June 8th 2012

Re: Application for a License under the Beach Control Act, 1955 in respect of the Construction and Maintenance of Three (3) Groynes, Two (2) Breakwaters, Dredging and Reclamation Works at Grand Palladium, Hanover - Ref: 2012-07017-BL00016

Figure 1-Georeferenced map showing the size of the impact area along with donor areas and monument coral locations

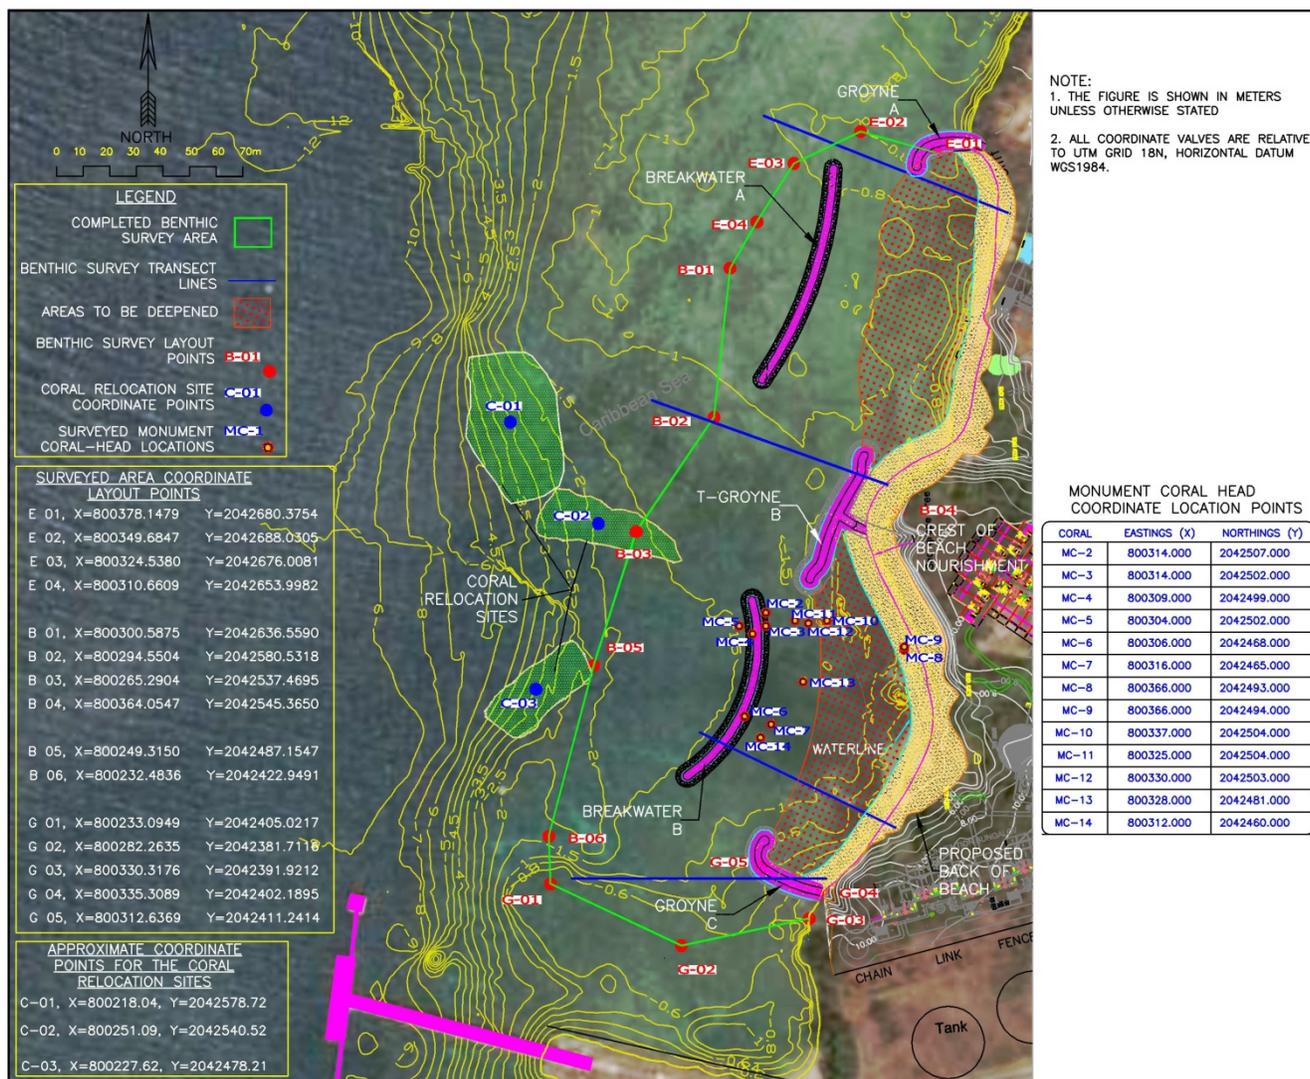
c. Geo-referenced location of all donor areas (where applicable)

Figure1 hereunder indicates the geo-referenced location of all donor areas. Additional geo-referenced locations are also shown in Figure 18 of the report by CL Environmental and CEAC. GPS coordinates were extracted from the C.L. Report for the spaces¹ that were found in the zone suitable for seagrass replanting, and these coordinates were uploaded into the GPS instrument. Each of the four areas identified as suitable spaces were snorkeled along with the surrounding seagrass meadow, and general observations were recorded. It should be noted that the structures shown in the main bay to the south in that figure, have not been built.

The proposed relocation/replanting sites for both coral and seagrass are mentioned in the CL Environmental Report. In addition proposed seagrass relocation sites are described in detailed in Sections 3 - 10, Seagrass Relocation Sites, of the Benthic Survey Addendum, while proposed coral relocation sites with geographic coordinates are detailed in Figure1 of this letter.
